**UNITED STATES ENVIRONMENTAL PROTECTION AGENCY
REGION 1
5 POST OFFICE SQUARE, SUITE 100
BOSTON, MA 02109-3912**

SUBJ: GE-Pittsfield/Housatonic River Site: EPA Response to GE
Statement of Position in Dispute Resolution Proceedings

EPA's RESPONSE TO GE'S STATEMENT OF POSITION ON DISPUTED CONDITIONS 20 AND 22 OF EPA'S JANUARY 15, 2010 CONDITIONAL APPROVAL LETTER

Figure G-1 – Method B for Determining Schedule for SED 9

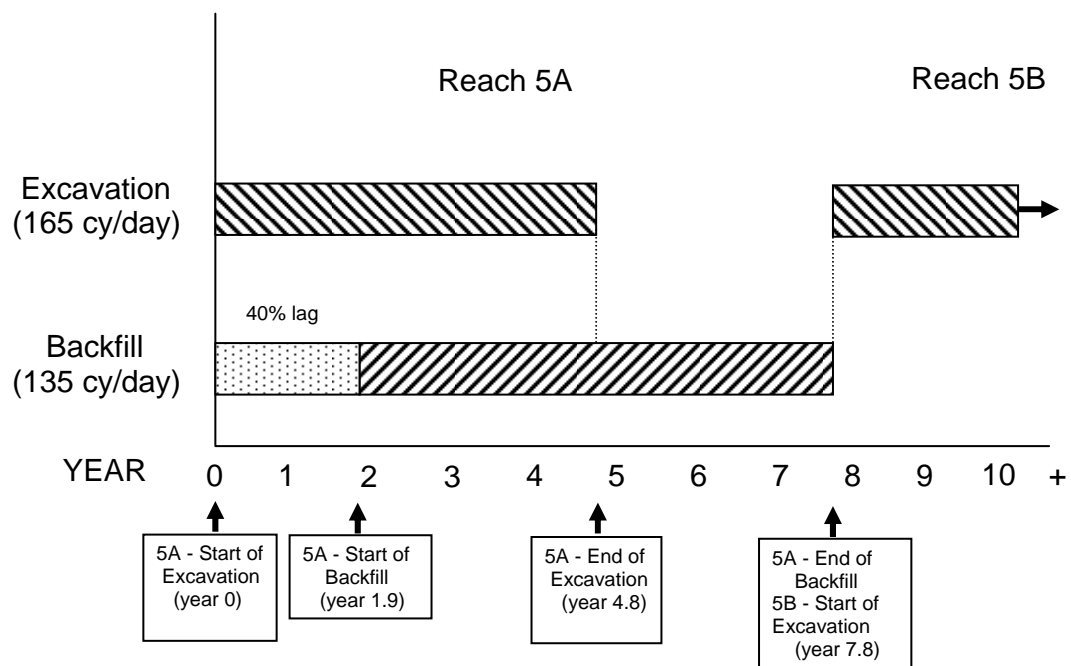
It thus appears that when calculating the overall durations for each Reach, GE factored in backfill in a manner that is inconsistent with GE's March 2009 response to Comment 49 (Attachment F, at 202). In addition, it appears that GE does not begin excavation in the downstream Reach until completion of backfill has occurred in the upstream Reach (Figure 1).

The volume of material to be excavated in Reach 5B includes 88,000 cy of sediment plus 9,000 cy of bank soil, for a total of 97,000 cy. The 33,000 cy of bank soil material agreed upon for Reaches 5A and 5B was pro-rated by the length of Reach 5A compared to the length of Reach 5B.

Bank soil excavation and backfill activities will be conducted concurrent to sediment excavation and backfill activities in Reaches 5A and 5B.

Frequency of River Velocity in Reaches 5B and 5C

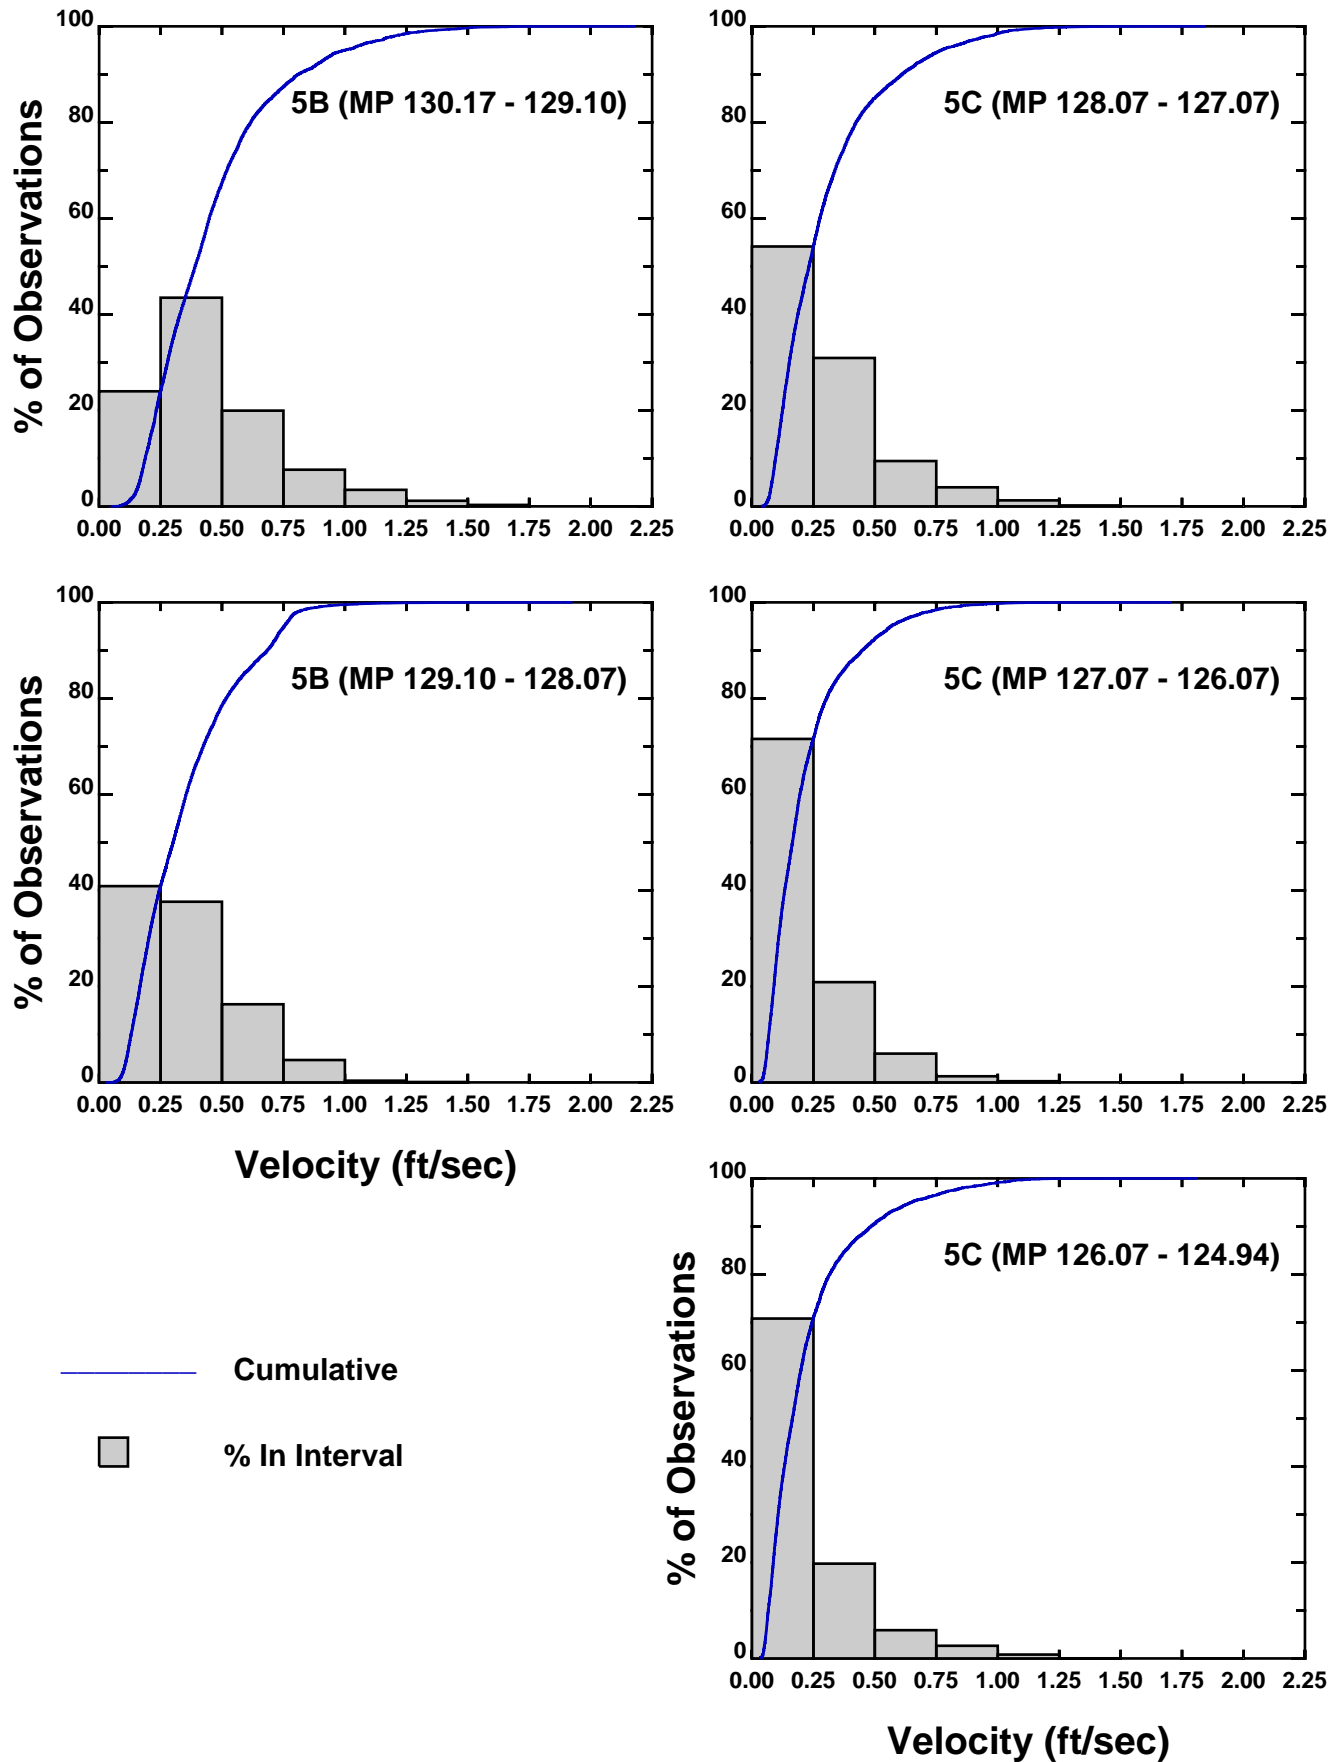
As discussed above, GE already factored 10% downtime into the 275 cy/day rate. GE did not explain at the time how much of that 10% was related to high flow events. EPA reasonably assumed a portion or all of the 10% downtime was due to high flow events. For example, in its January 29, 2010 dispute letter, GE claims that the “198 working days per year for more downstream reaches assumed no *or a lesser number* [than around 30 days in Reach 5A or 15 days in Reach 5B] of flow-related shutdown days.” (Attachment D, at 4, emphasis added). Thus, GE clearly factored in “flow-related” downtime into the average daily production rate of 275 cy/day for mechanical excavation via a barge-mounted excavator. Also, as discussed above, EPA assumed that the average daily production rate of 275 cy/day *did* include consideration of anticipated flow shutdowns. (Attachment I, at 6).

⁹ GE changed the number of days assumed to be downtime for high flow from their Work Plan and January 31, 2010 letter from 30 days to 36 days in their Statement of Position (Attachment E, at 7). EPA calculates that the 36 days will result in an 18% reduction in the production rate due to flow.
